FORESTSIDE TOWNHOUSES

SITE INSTRUCTION # 4

Date: May 21st, 2021

JAP Project No: 19066

S-105B

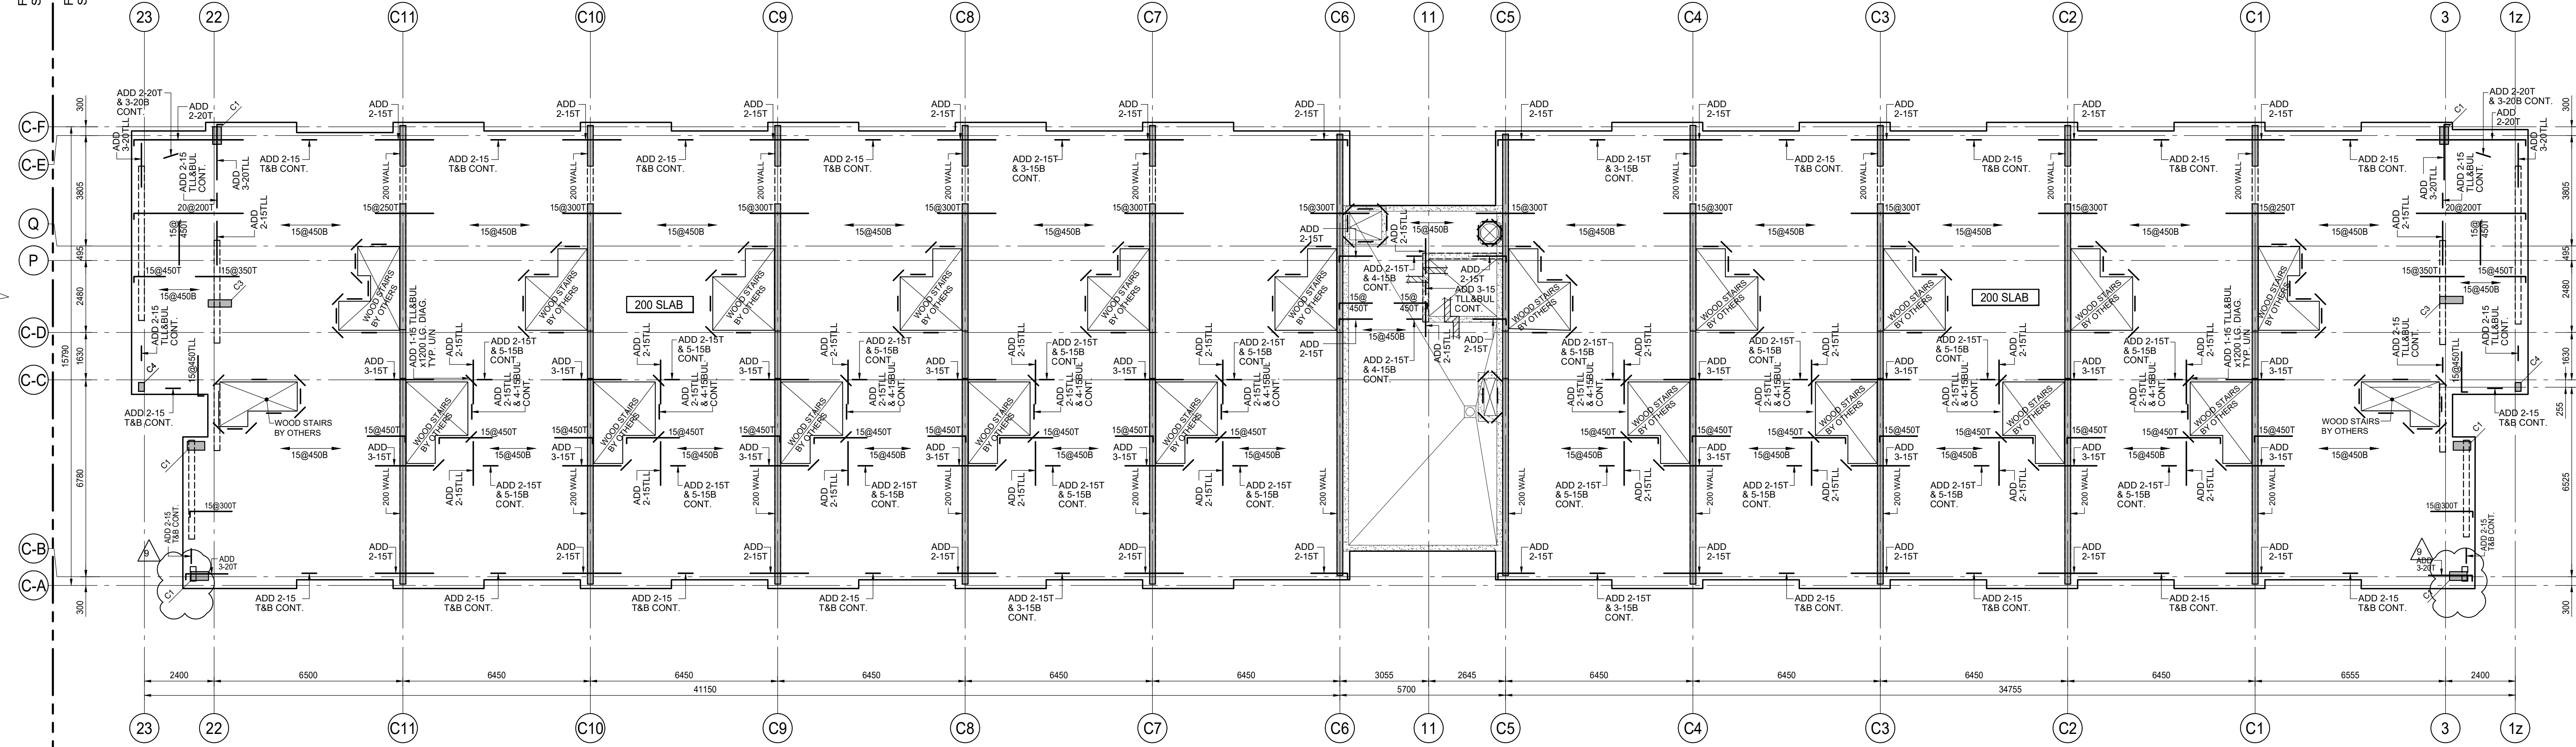
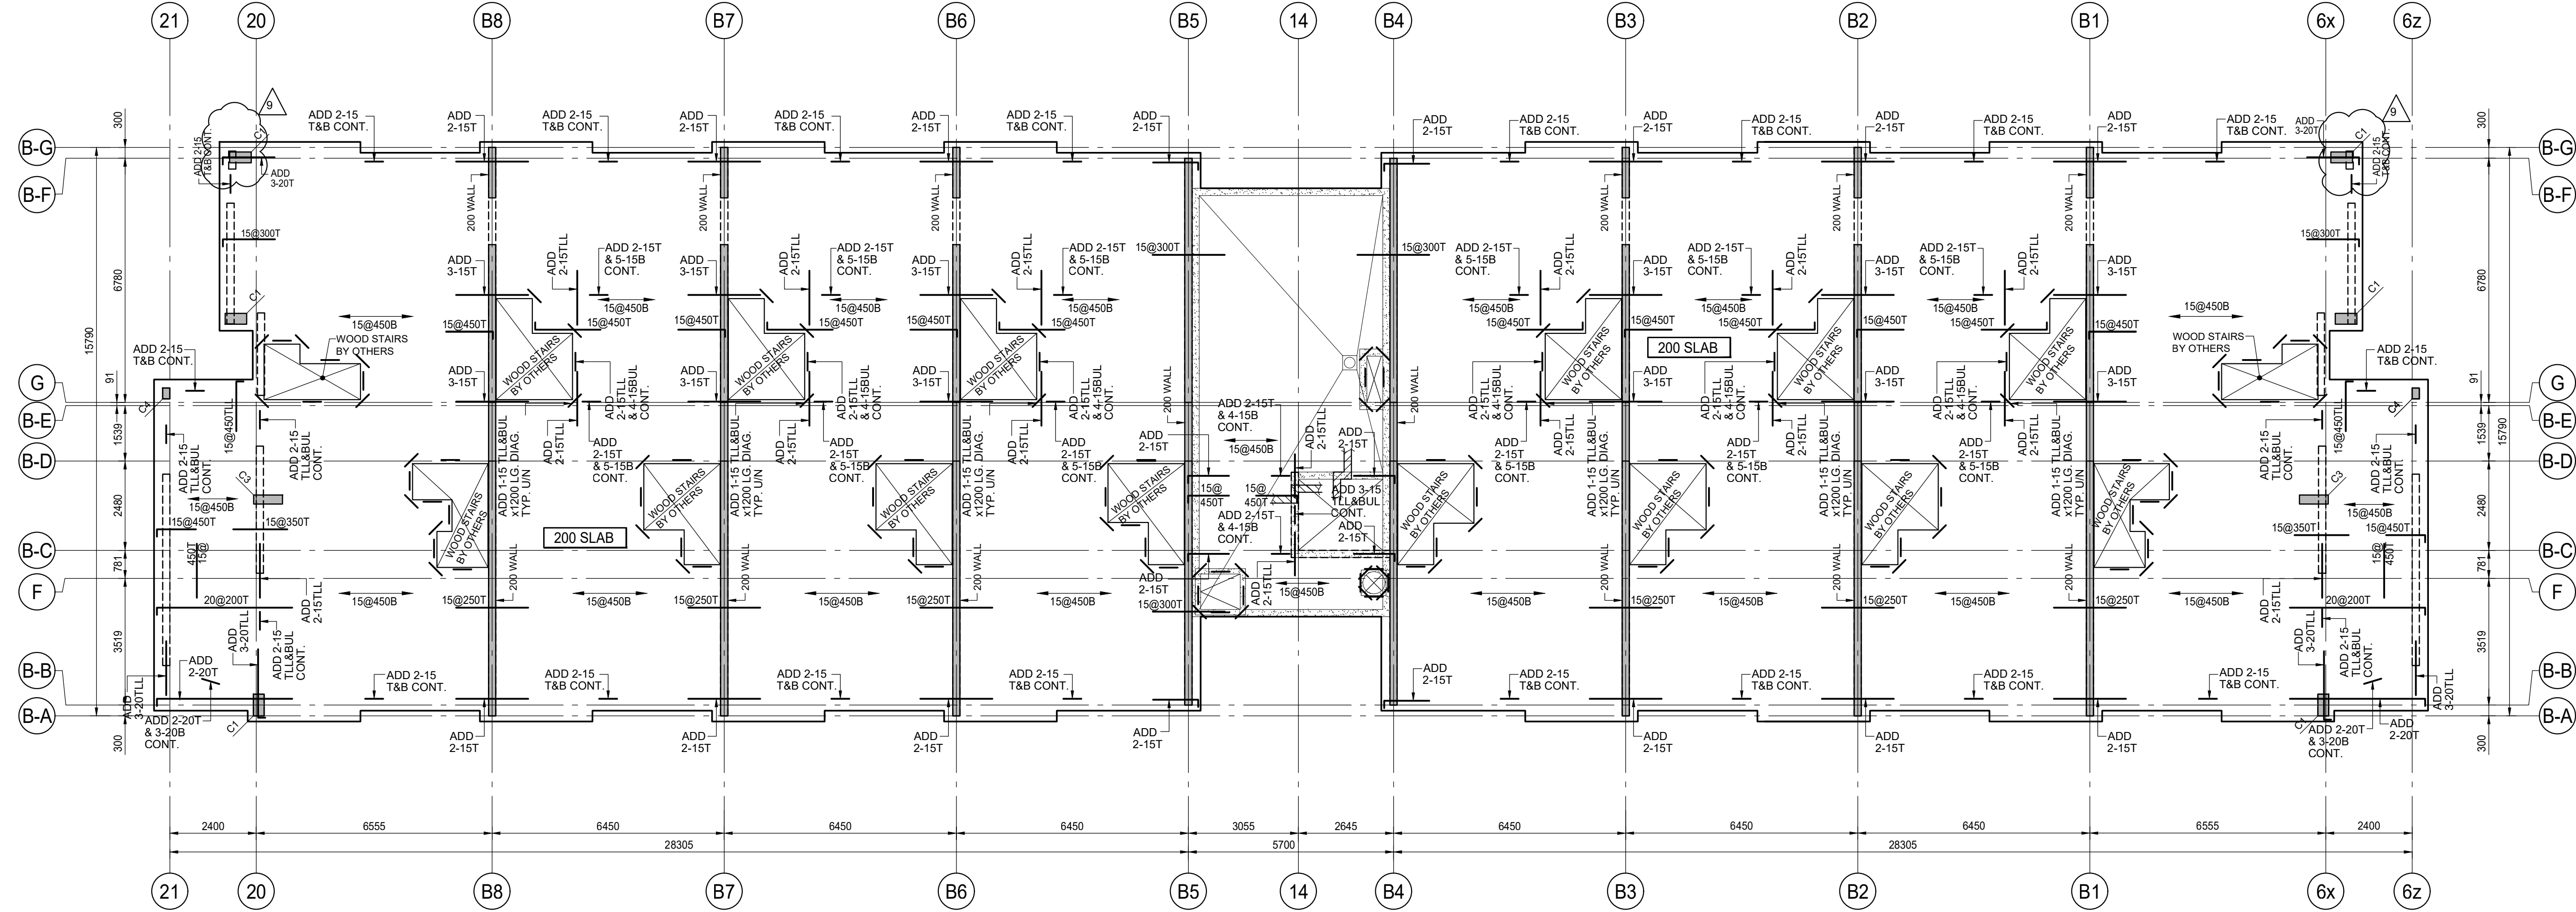
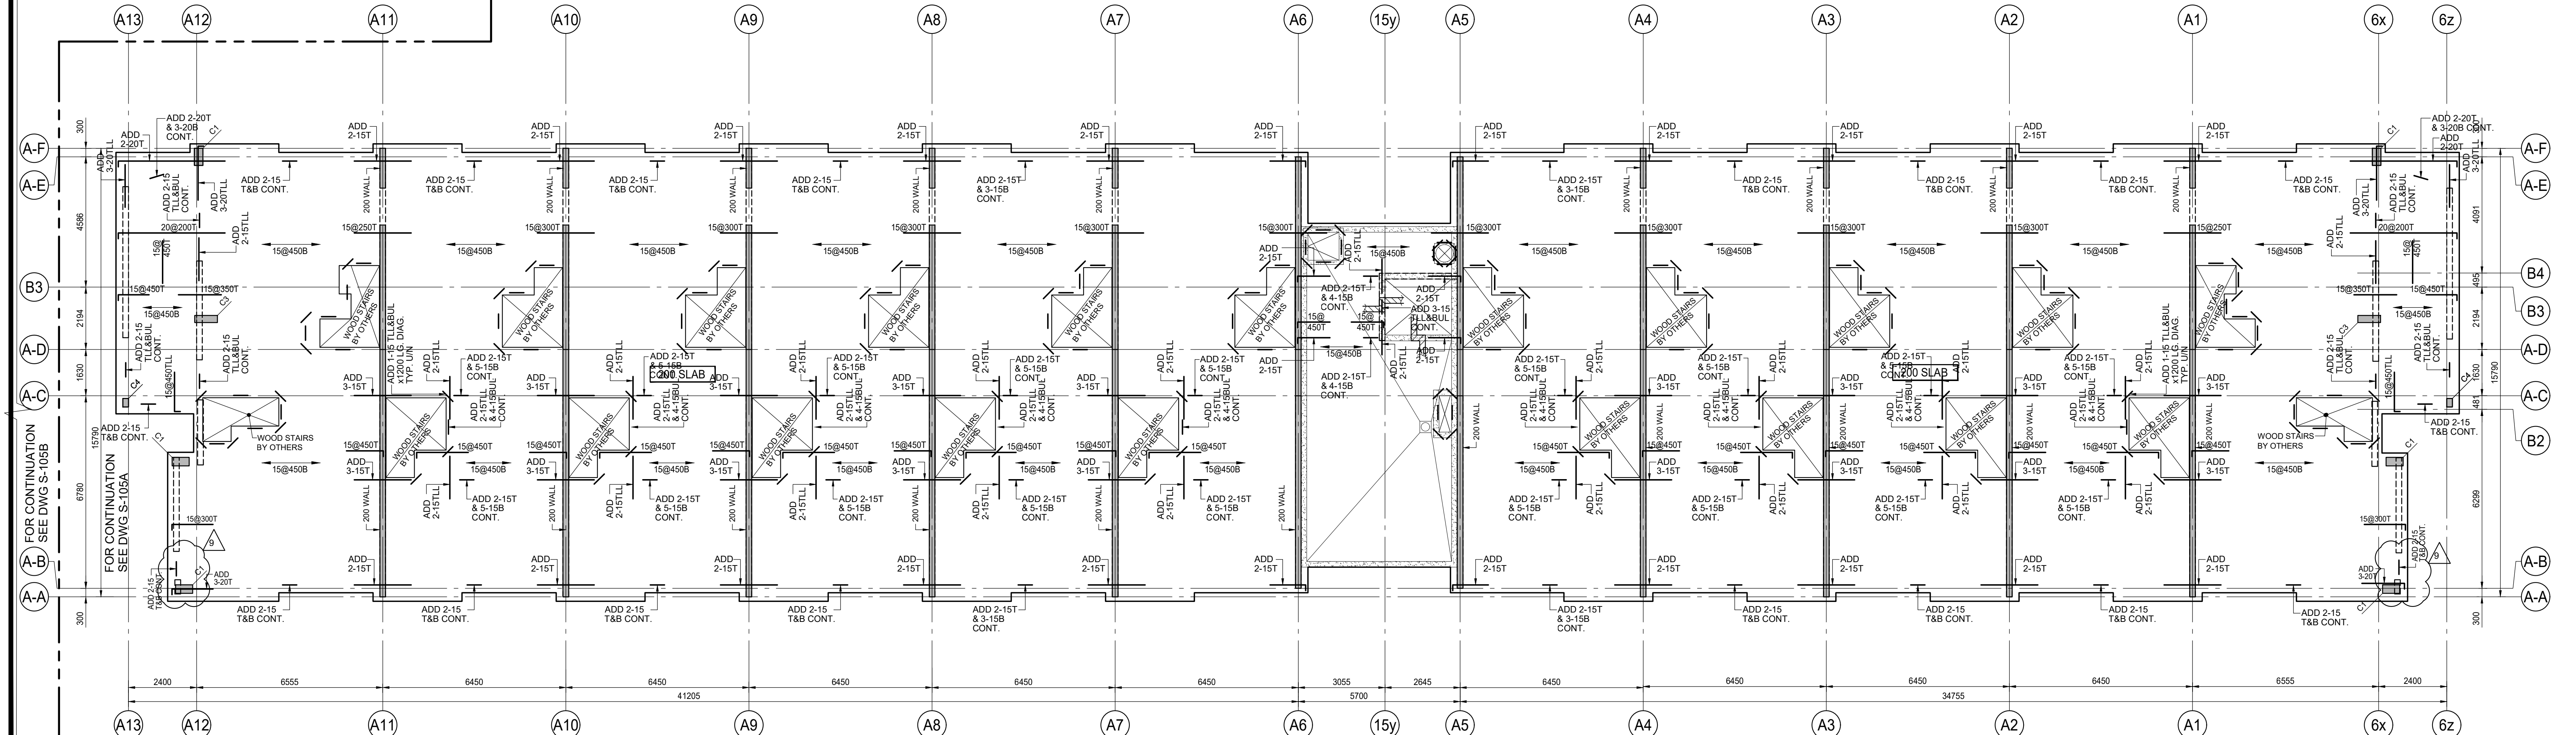
1.5 **Refer to Drawing S-105A & B "4TH FLOOR FRAMING PLAN"**

- n) Matched latest column location from arch

Job No: 19066 Sheet No: S-201

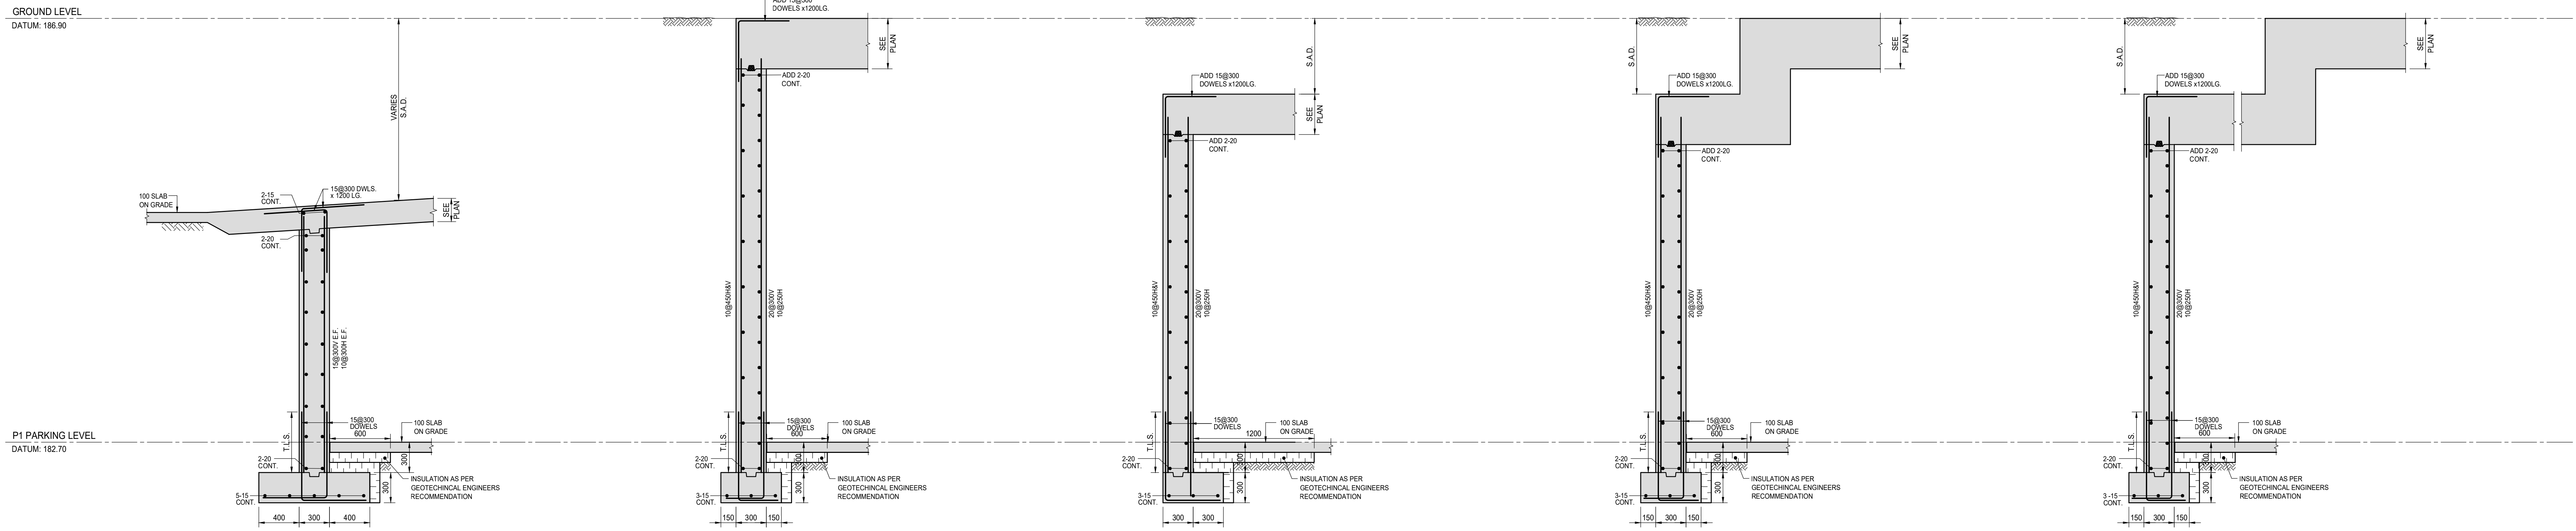
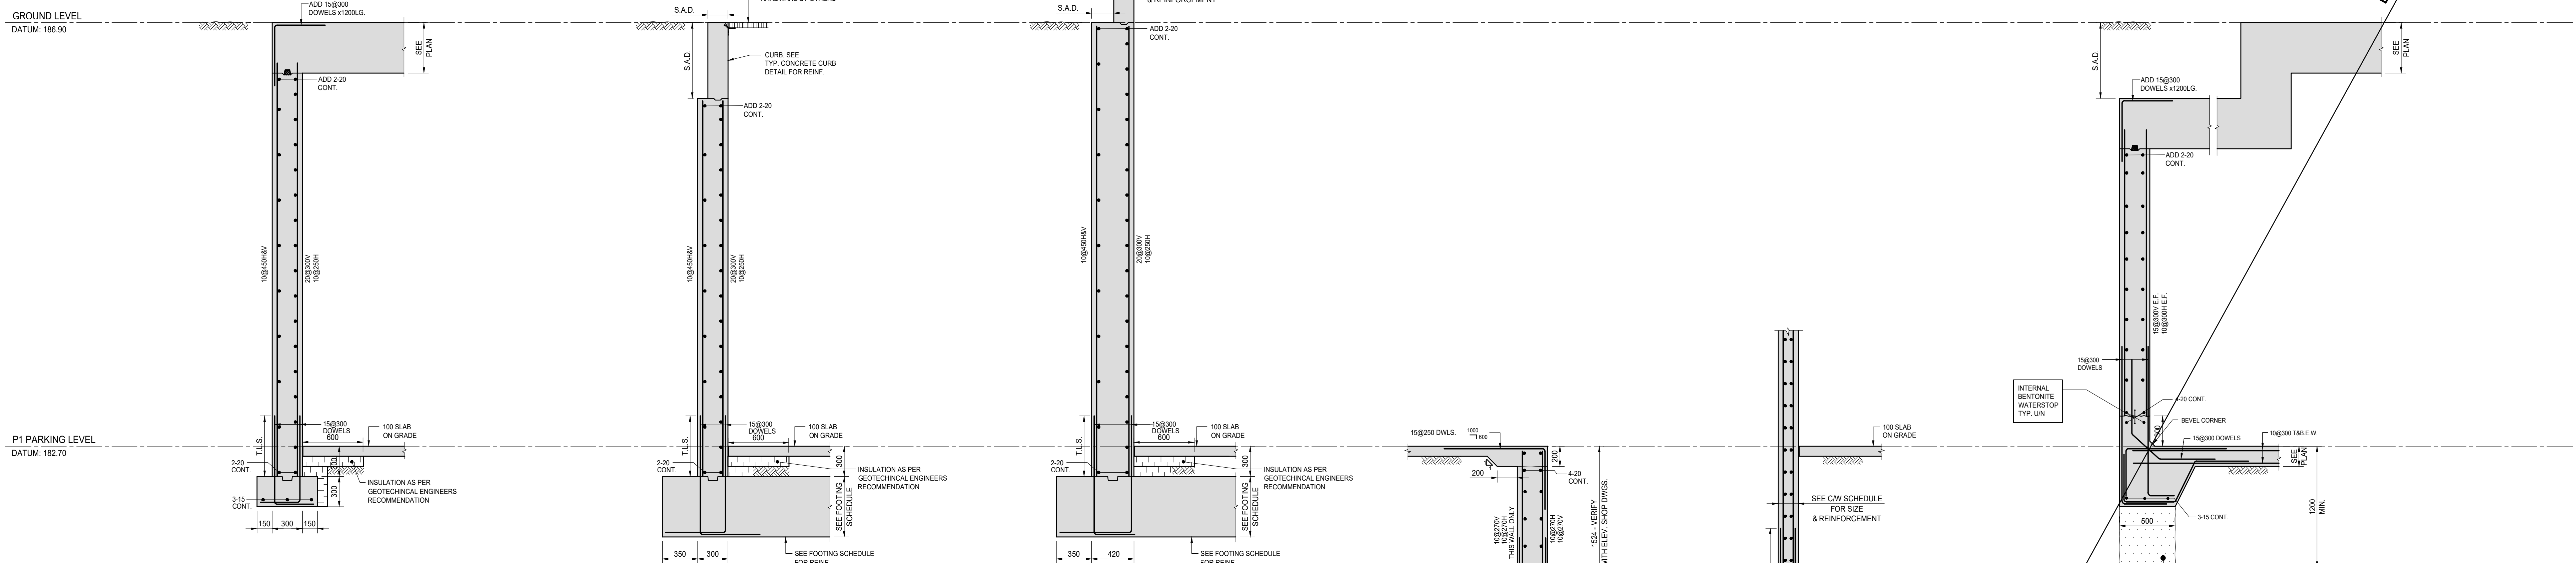
1.6 **Refer to Drawing S-201 "Foundation section"**

- o) Updated elevator pit depth
- p) Added dimension to show 300mm from top of SOG to top of footing in all sections
